UNITED STATES
DEPARTMENT OF THE INTERIOR
BUREAU OF LAND MANAGEMENT
APPLICATION FOR PERMIT TO DRILL OR REENTER

¹ API Number 30-025-51247		² Pool Code 98097		³ Pool Name SANDERS TANK; UPPER WOLFCAMP					
⁴ Property Code 326144		⁵ Property Name MESA B 8115 FED COM						⁶ Well Number 43H	
⁷ OGRID No. 260297		⁸ Operator Name BTA OIL PRODUCERS, LLC						⁹ Elevation 3314'	
¹⁰ Surface Location									
UL or lot no. A	Section 7	Township 26S	Range 33E	Lot Idn	Feet from the 430	North/South line NORTH	Feet from the 300	East/West line EAST	County LEA
¹¹ Bottom Hole Location If Different From Surface									
UL or lot no. P	Section 7	Township 26S	Range 33E	Lot Idn	Feet from the 50	North/South line SOUTH	Feet from the 350	East/West line EAST	County LEA
¹² Dedicated Acres 637.36		¹³ Joint or Infill		¹⁴ Consolidation Code		¹⁵ Order No.

PECOS DISTRICT DRILLING CONDITIONS OF APPROVAL

OPERATOR'S NAME:	BTA Oil Producers
LEASE NO.:	NMNM160973
WELL NAME & NO.:	MESA B 8115 Fed Com 43H
SURFACE HOLE FOOTAGE:	430'/N & 300'/E
BOTTOM HOLE FOOTAGE:	50'/S & 350'/E
LOCATION:	Section 7, T.26 S., R.33 E., NMP
COUNTY:	Lea County, New Mexico

CasingHead Assembly Lower
MBH

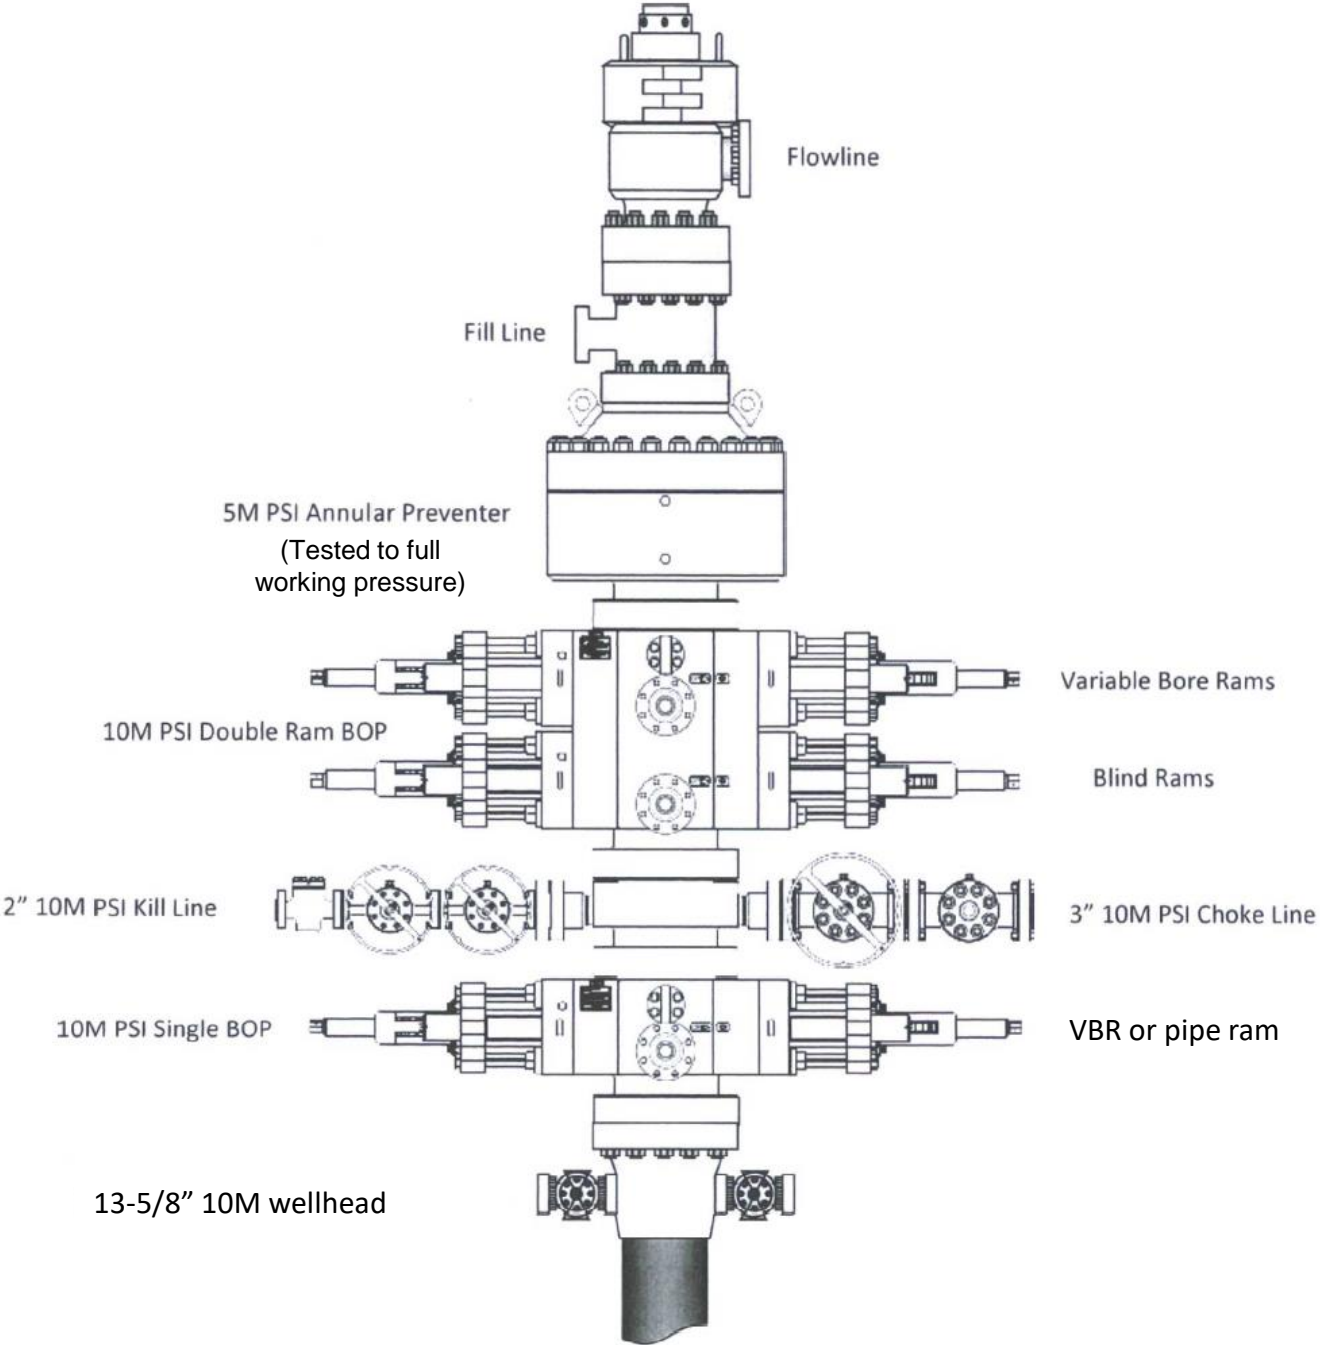
2. Operator has proposed a multi-bowl wellhead assembly. This assembly will only be tested when installed on the surface casing. Minimum working pressure of the blowout preventer (BOP) and related equipment (BOPE) required for drilling below the surface casing shoe shall be **10,000 (10M) psi. Variance is approved to use a 5000 (5M) Annular which shall be tested to 5000 (5M) psi.**

- a. Wellhead shall be installed by manufacturer's representatives, submit documentation with subsequent sundry.
 - b. If the welding is performed by a third party, the manufacturer's representative shall monitor the temperature to verify that it does not exceed the maximum temperature of the seal.

- e. Whenever any seal subject to test pressure is broken, all the tests in OOGO2.III.A.2.i must be followed.
